KAWASAKI ELECTRO-HYDRAULIC STEERING GEAR SERVICE NEWS		ISSUE : JUL, 14, 2026 DOC.NO. E8-26-012
--	--	--

SUBJECT :	V Series Steering Gear Spare Solenoid Valve Type for Solenoid Hydraulic Valve
-----------	--

Fig-1. Solenoid hydraulic valve and solenoid valve

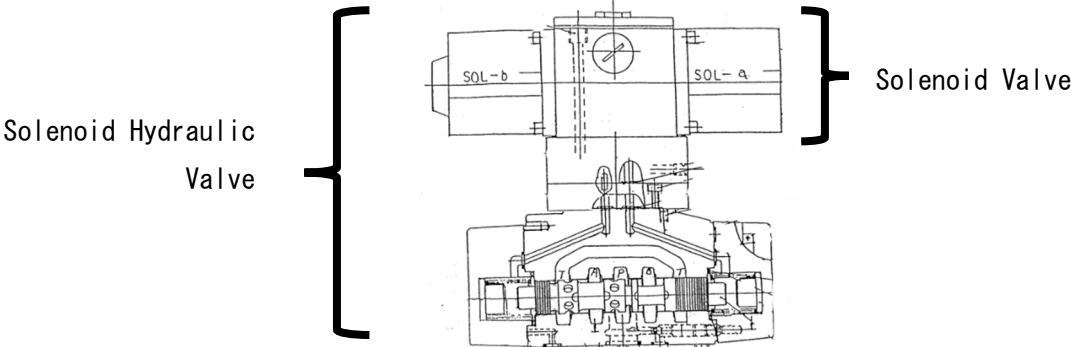
When replacing the solenoid valve in the solenoid hydraulic valve with a spare part, we sometimes receive inquiries if the type and hydraulic symbol listed on the nameplate differ between the installed part and the spare part. As shown in Fig-1, this is because the installed part displays the type for the entire solenoid hydraulic valve, whereas the spare part displays the type only for the solenoid valve itself.

Solenoid valves with corresponding type listed in Table-1 can be used as replacement spare parts.

When replacing the solenoid valve, please ensure it is assembled carefully to avoid pinching the O-ring, and tighten the bolts to the tightening torque specified in the instruction manual.
